CITY OF NEW YORK
DEPARTMENT OF SANITATION
MARINE EXPORT OF SOLID WASTE
SOUTHWEST BROOKLYN
MARINE TRANSFER STATION

EXISTING GRADING AND DEMOLITION PLAN

**FINAL SITE FINISHES
PHASE**

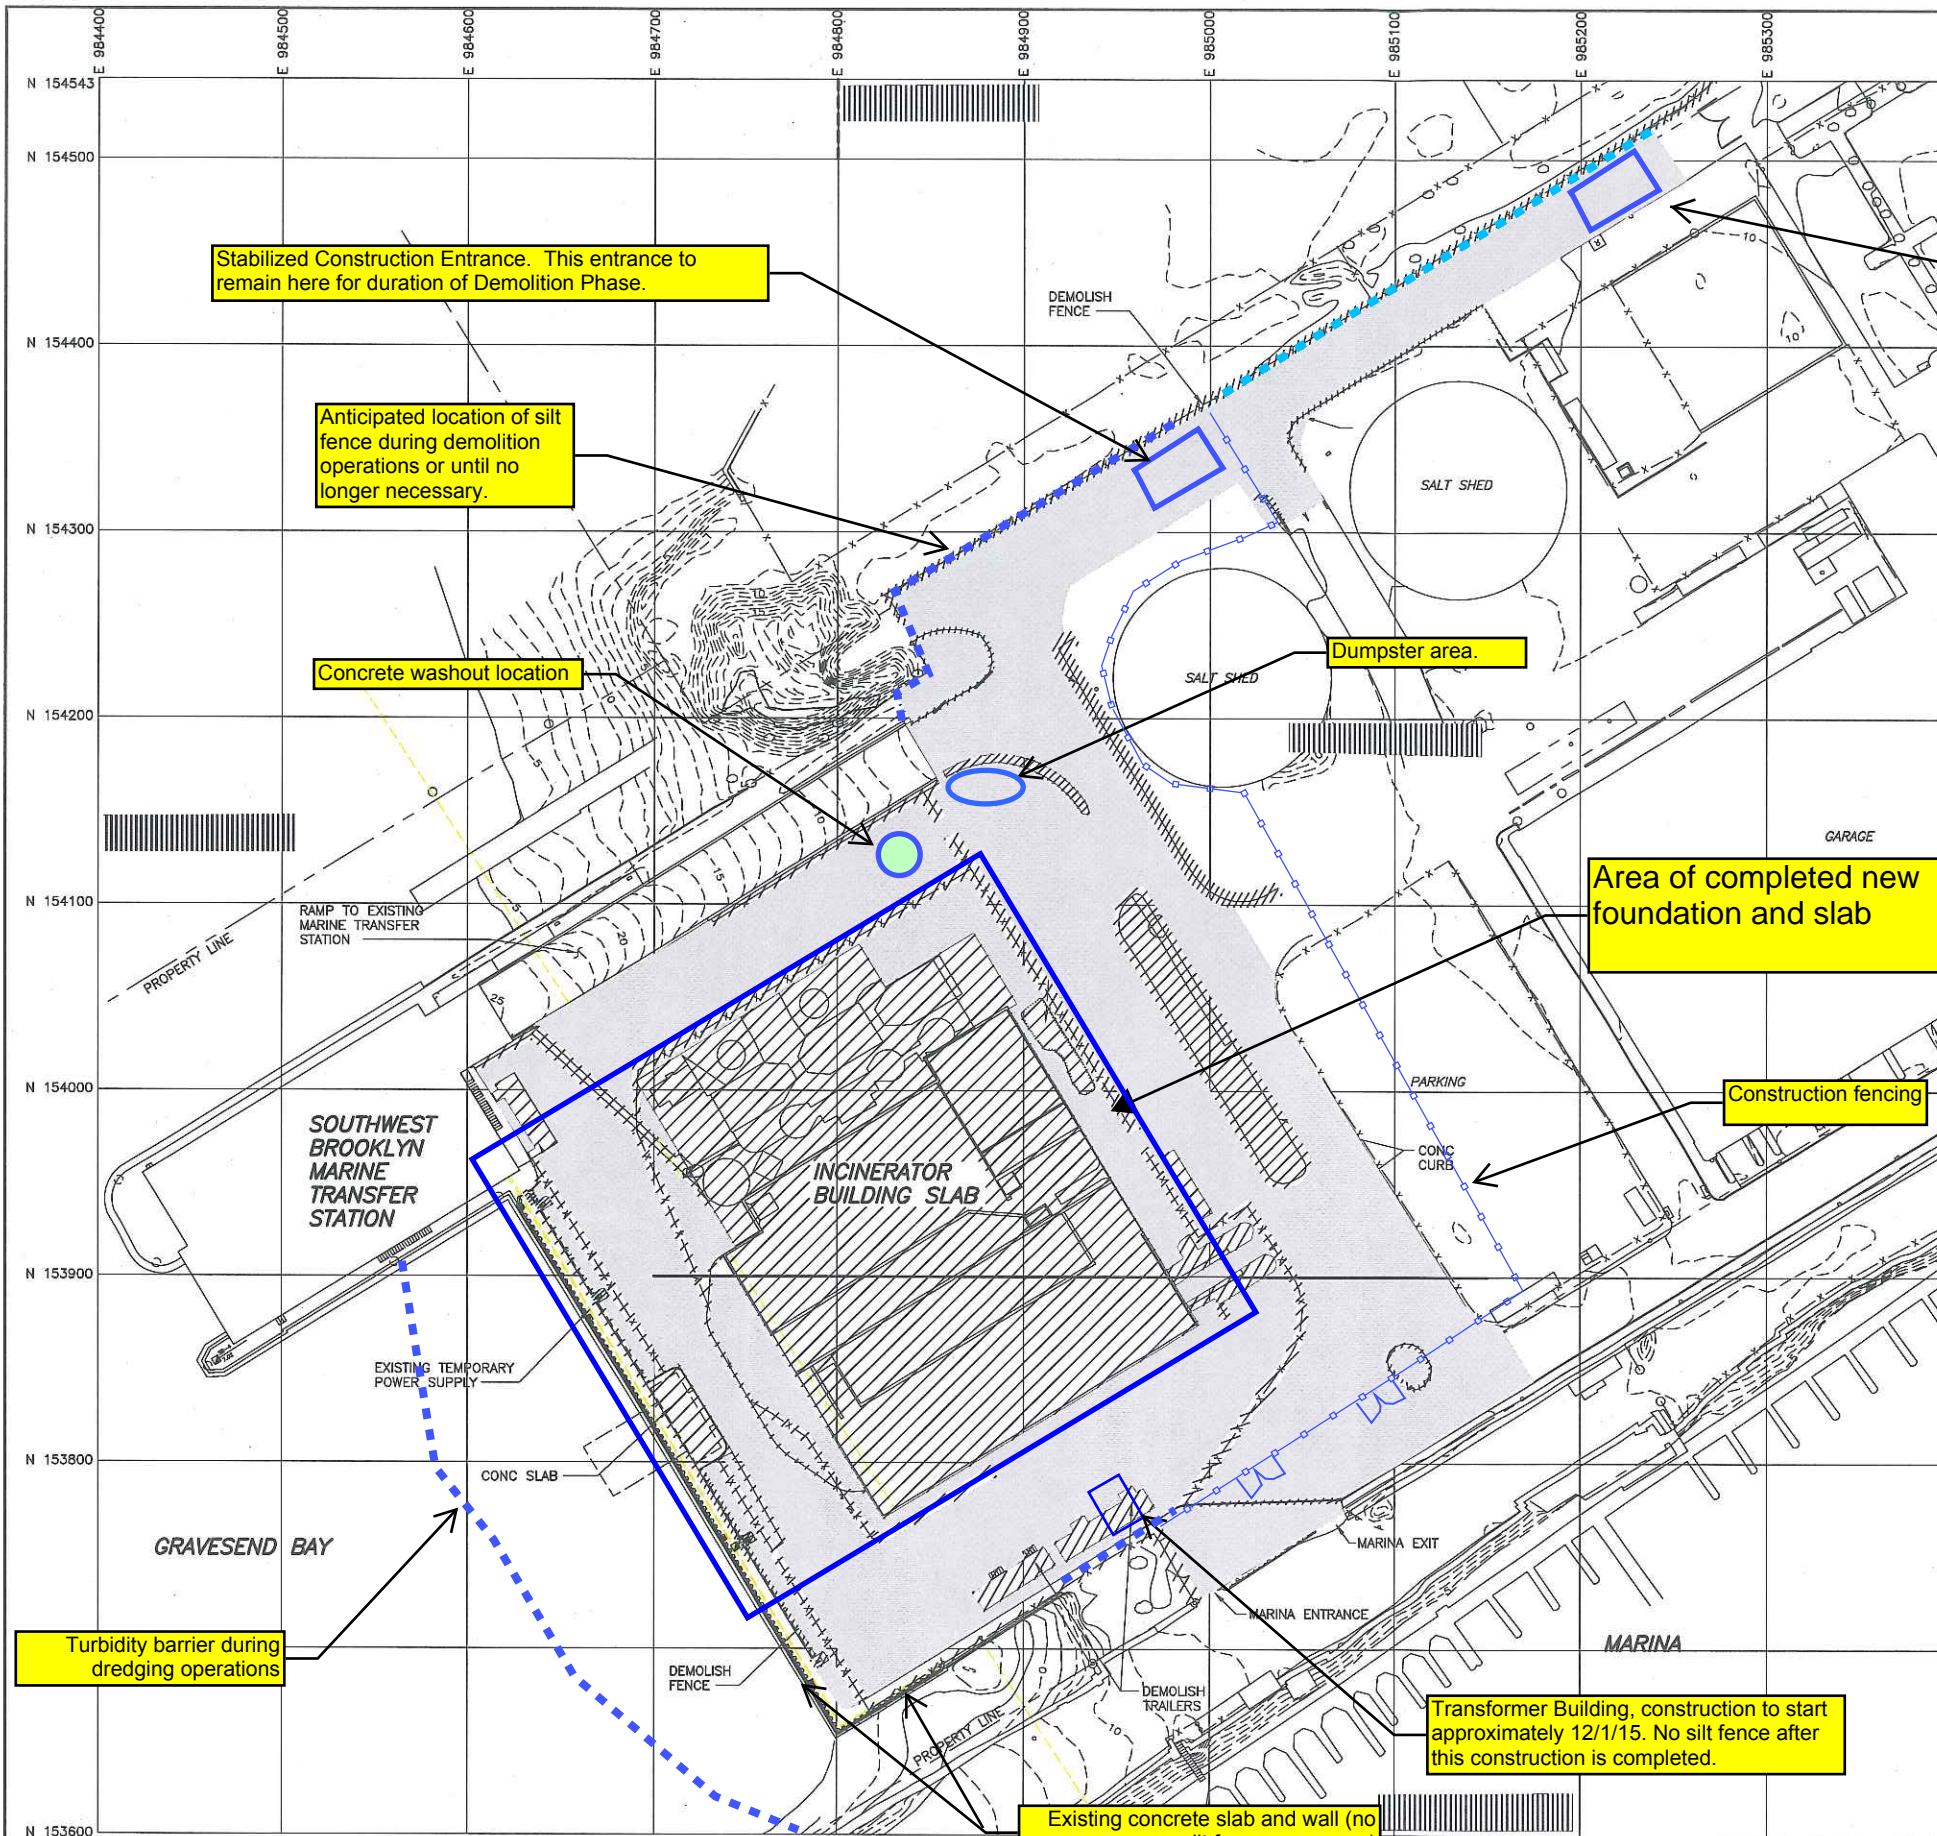
Stabilized Construction Entrance. This entrance will be utilized when existing asphalt is demolished during Final Site Finishes Phase.

PDC Notes:
1) All existing drainage structures have been disconnected and demolished and are inactive.
2) Silt fence will be removed from all areas when it is no longer necessary.

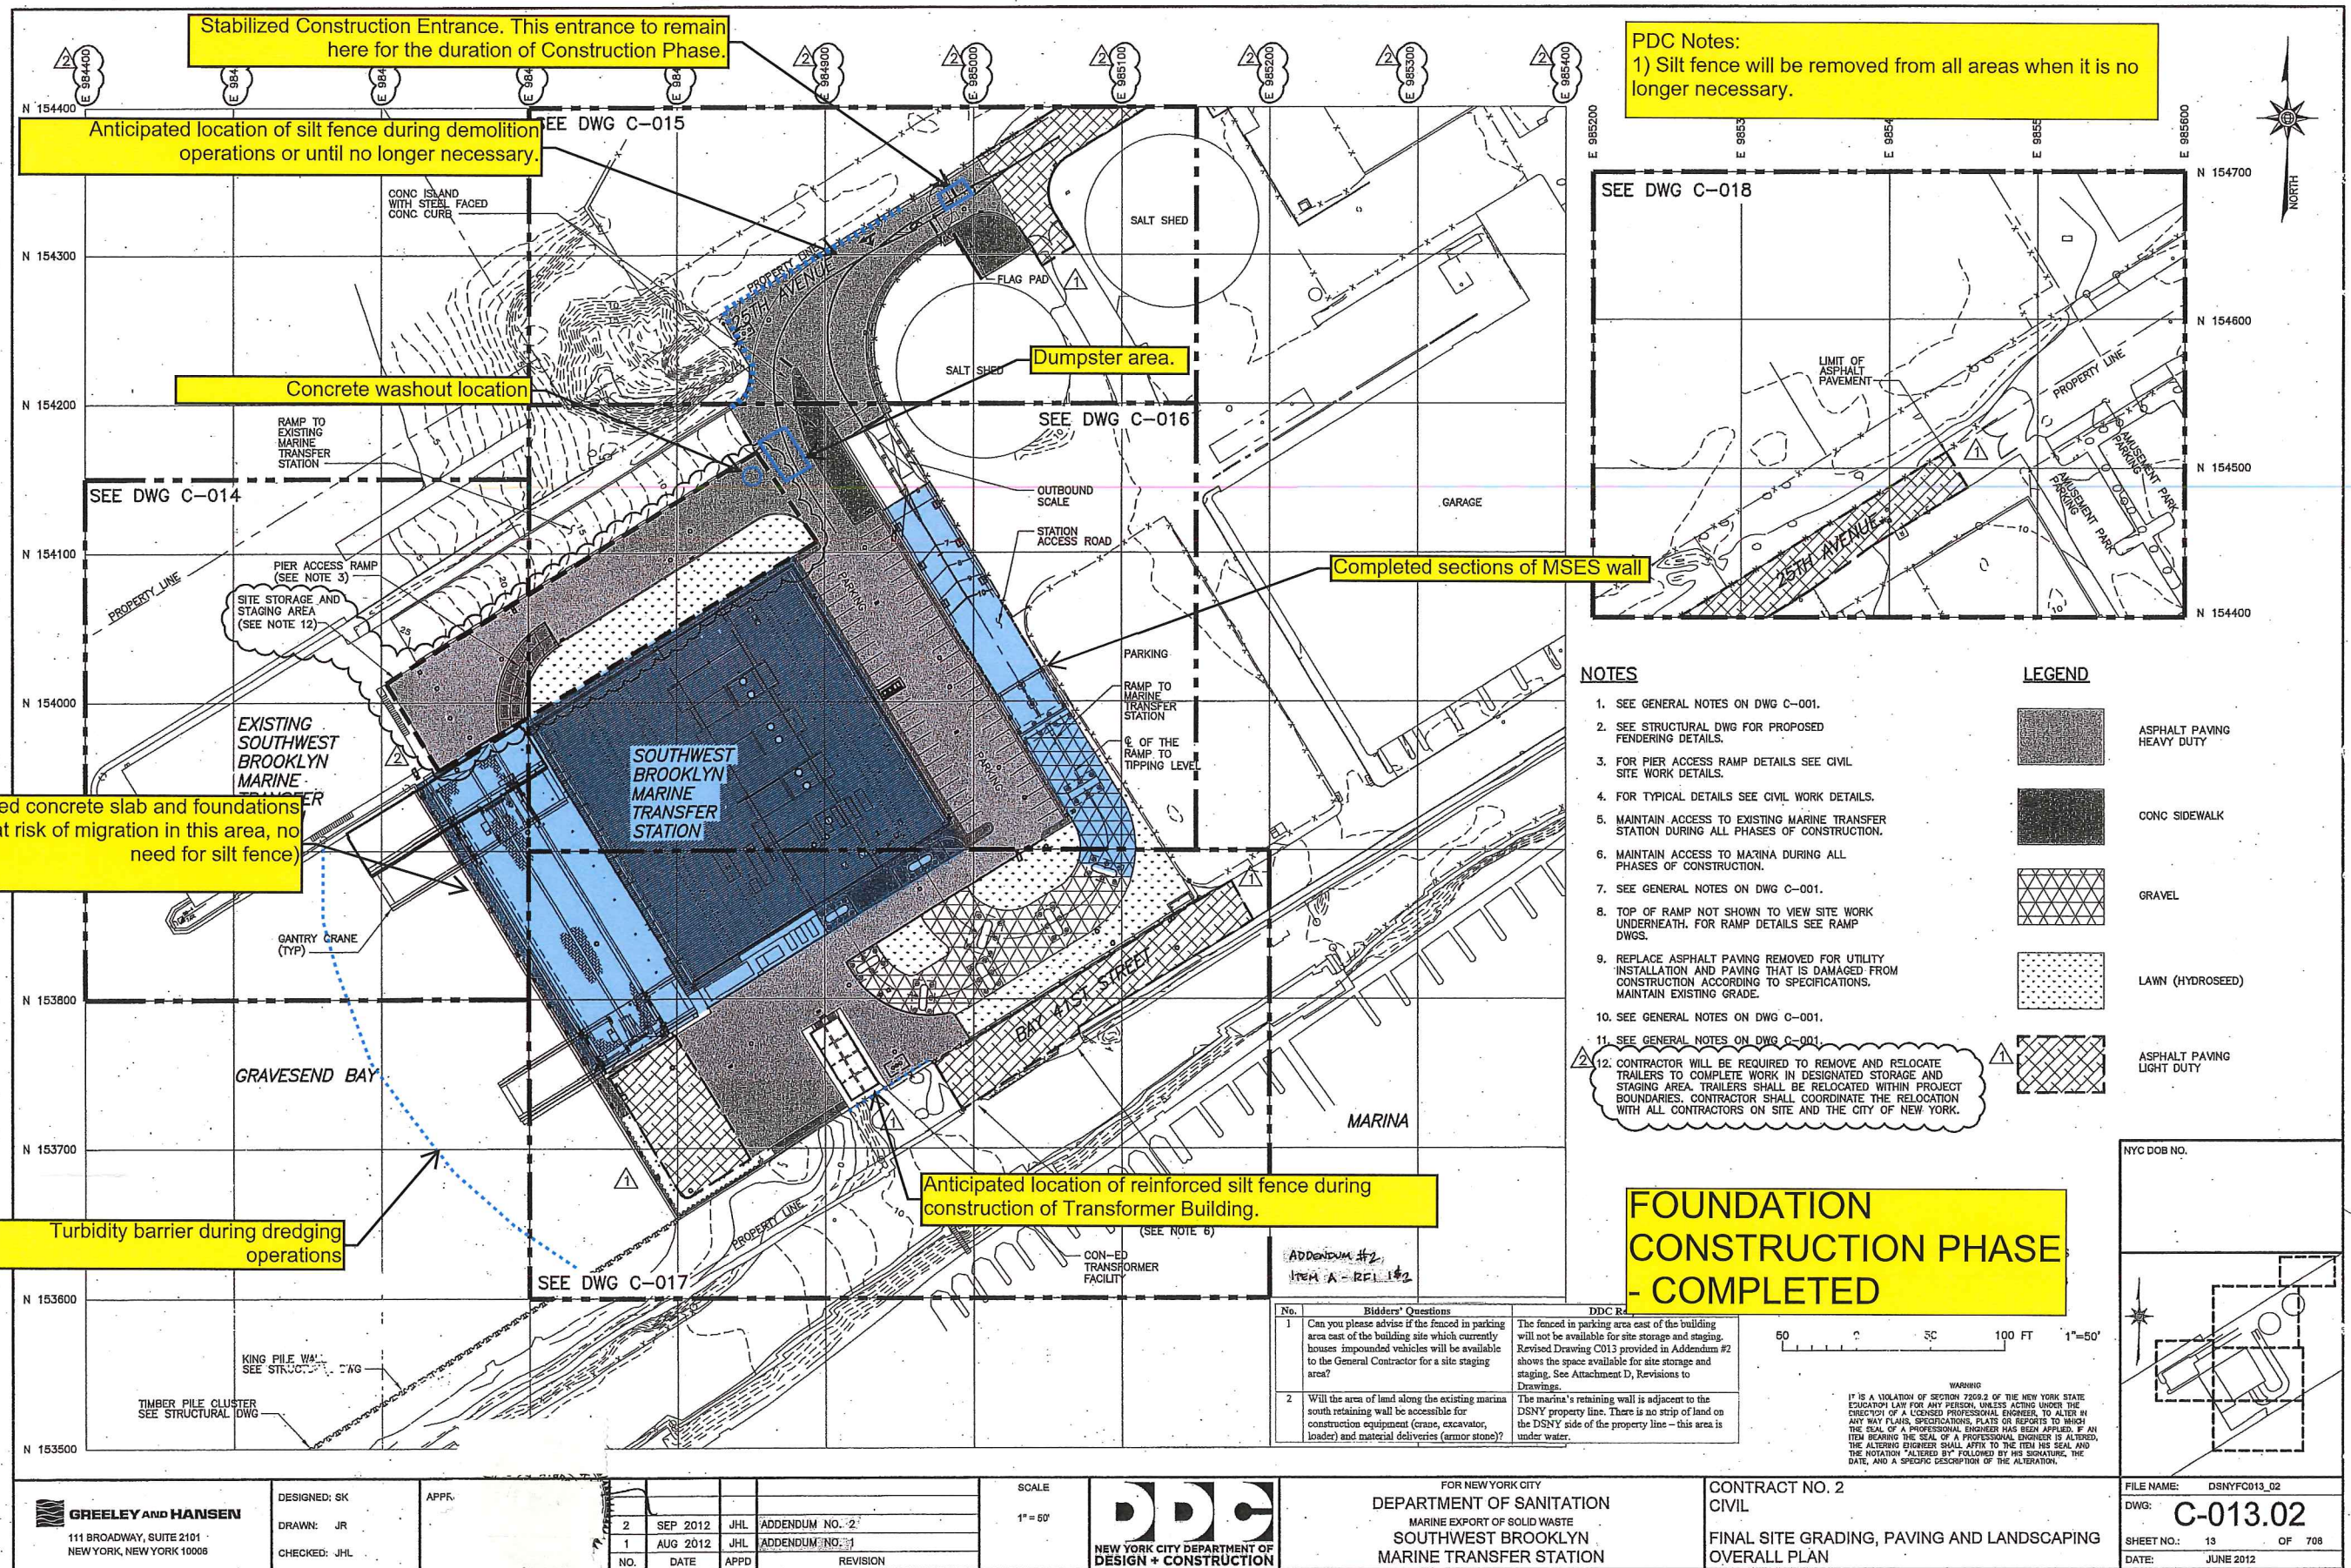
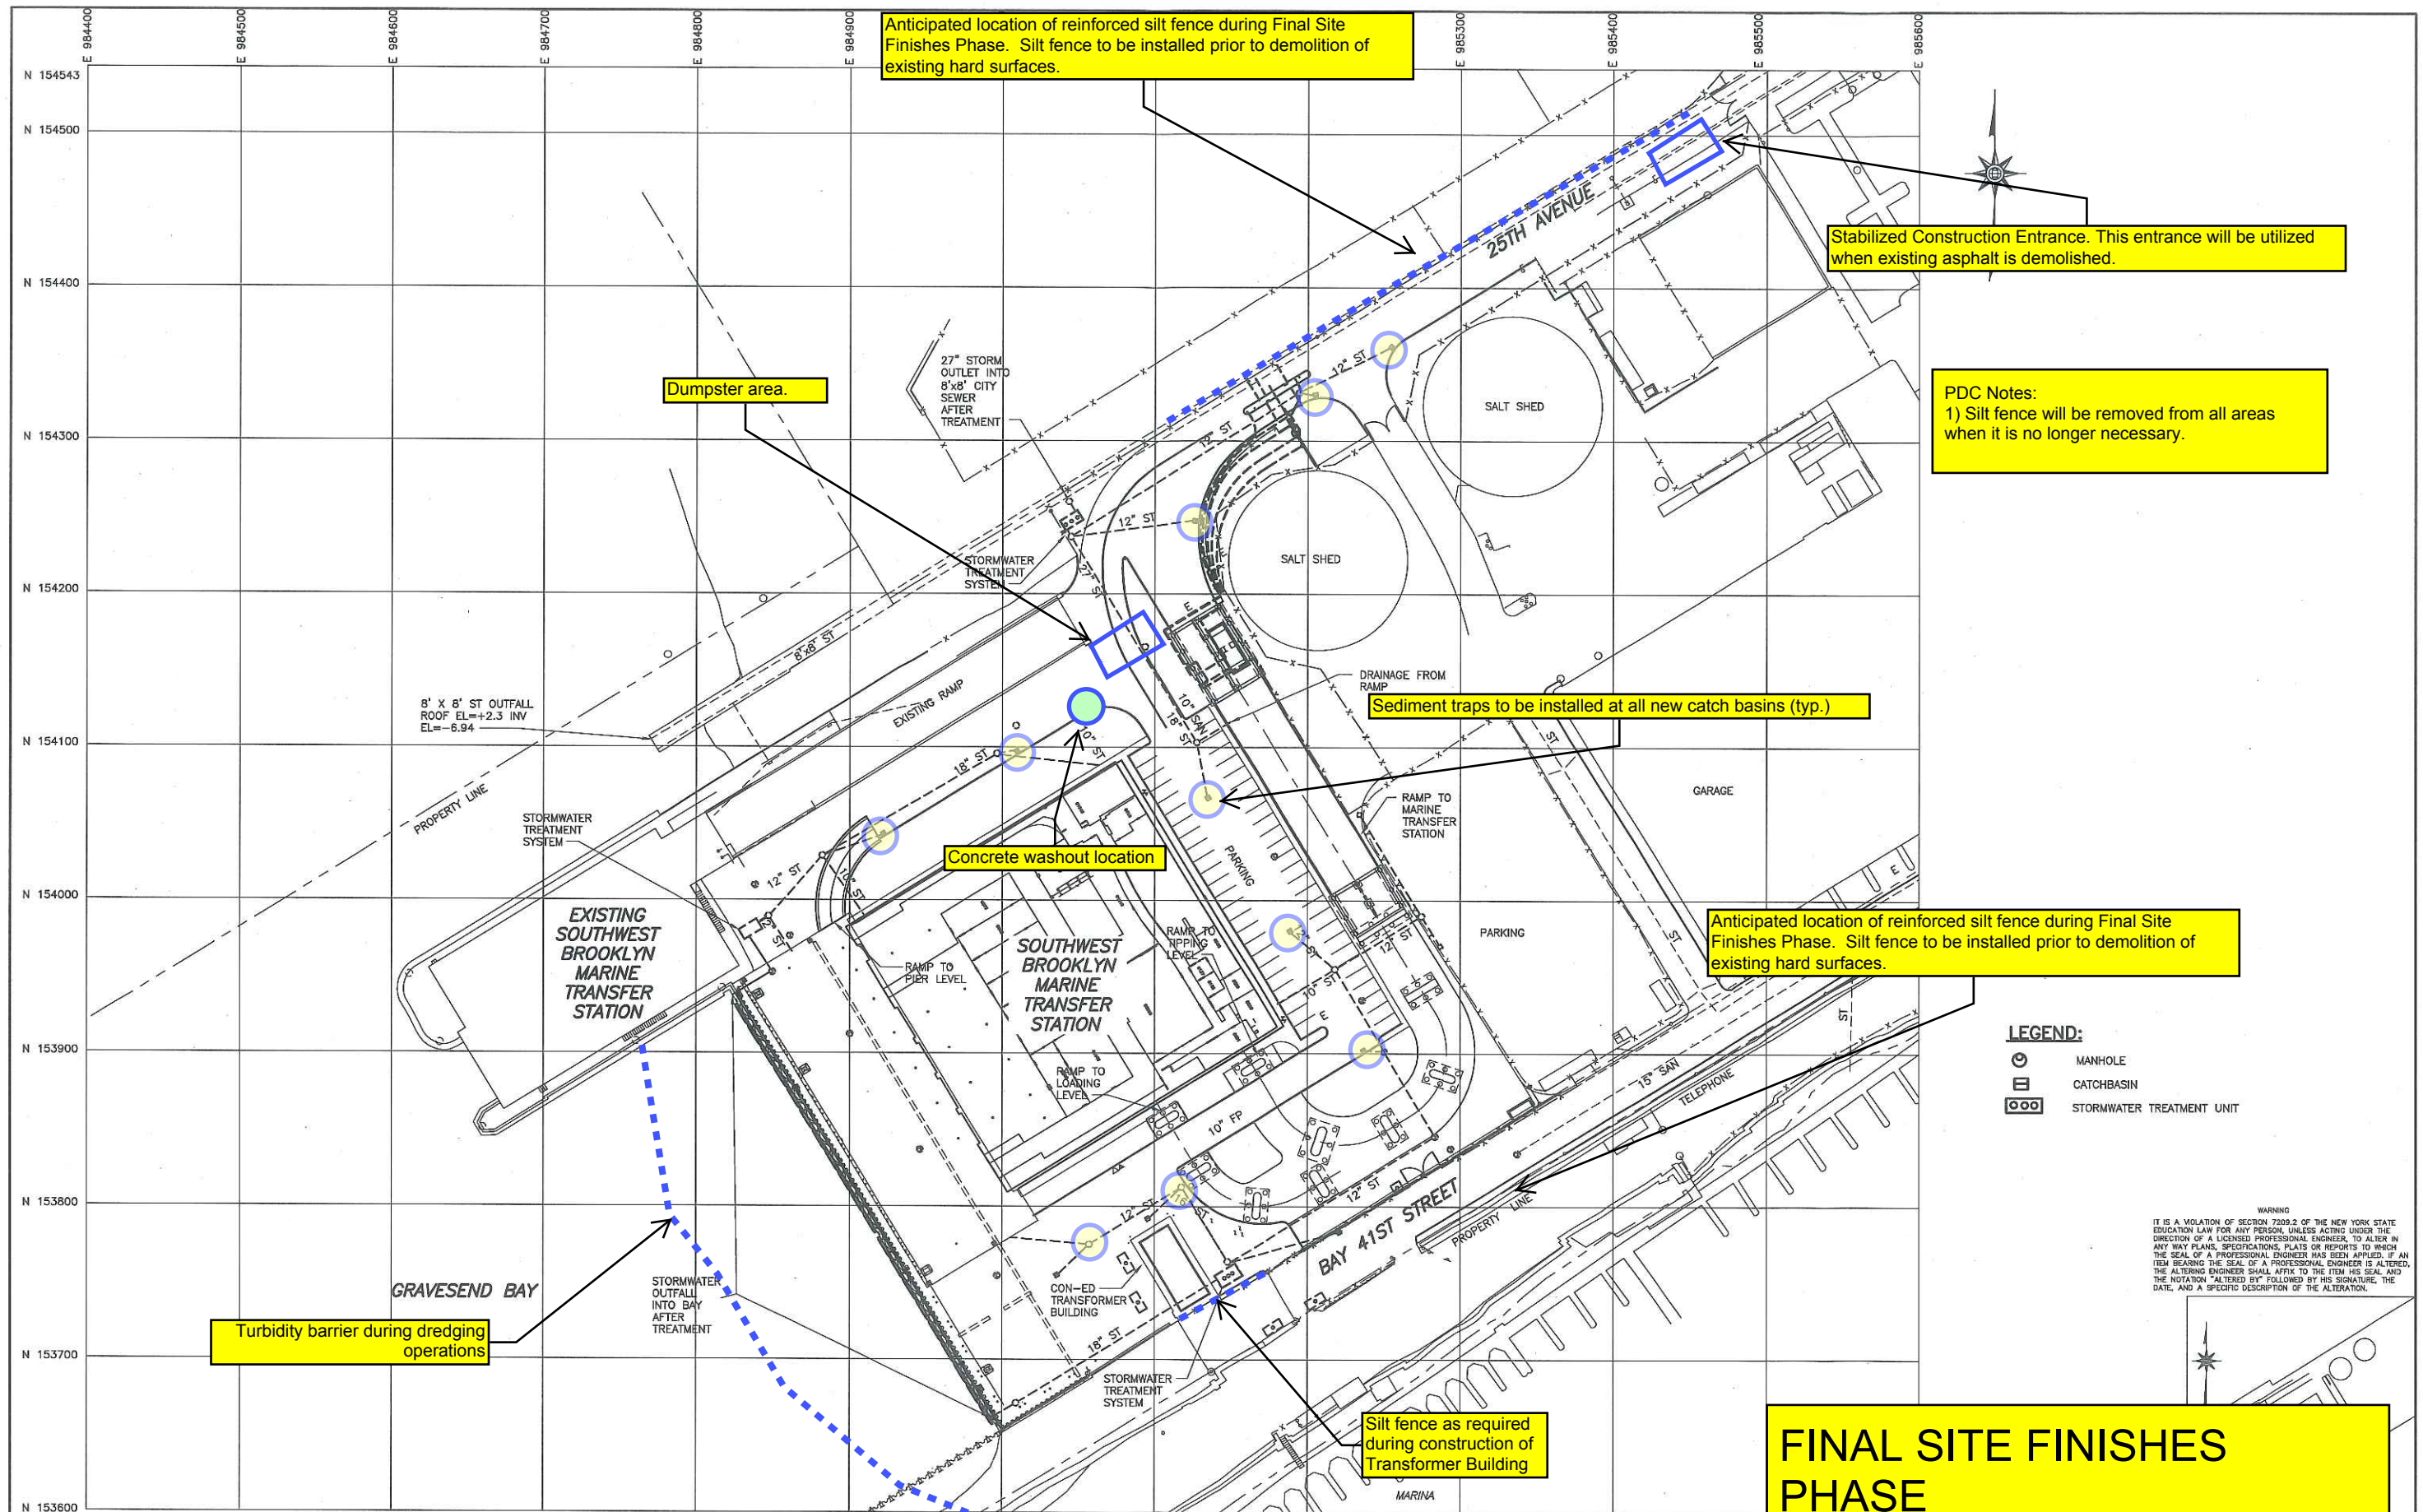
Anticipated location of reinforced silt fence during Final Site Finishes Phase. Silt fence to be installed prior to demolition of existing hard surfaces.

Stabilized Construction Entrance. This entrance will be utilized when existing asphalt is demolished.

PDC Notes:
1) Silt fence will be removed from all areas when it is no longer necessary.

Sediment traps to be installed at all new catch basins (typ.)

Concrete washout location

Anticipated location of reinforced silt fence during Final Site Finishes Phase. Silt fence to be installed prior to demolition of existing hard surfaces.
